Product Change Notification (PCN)

PCN Number	501881	Date Issued	March 17, 2017
Reason for Change	Change to Product		
Change Type Description	This letter is to inform you that changes are being made to the part(s) identified in this Notice. The change will affect the fit, form, function or appearance of the parts. Or, it may result in a change to the specification. The pictures below show an example of the possible differences.		
Reason for Short Notice	Special Request		
Assessment of Change	Test report/Specification Test Report		
Internal Molex Qualification Date	December 01, 2016		
Sample Availability Date (Changed Part)	December 01, 2016		
Planned Implementation Date	November 01, 2017		
Method of Identifying Change	Lot information on label

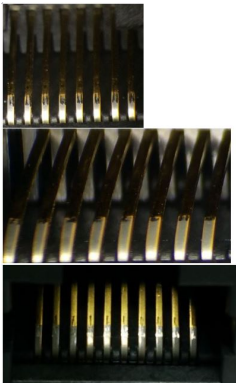
- Plating process will be changed with the project transfer from LNK to CD. The new plating will have gold flash in the initial contact area and 50u gold in the contact resting area vs. the old process with nickel plating in initial contact area and 50u gold in the contact resting area. The only impact is the slight visual difference to the terminal plating, otherwise fit and function are not affected.
- Product Impact
 - no impact to fit and function
- Part Number Impact
 - see attached impacted parts list
- PPAP and samples available upon request
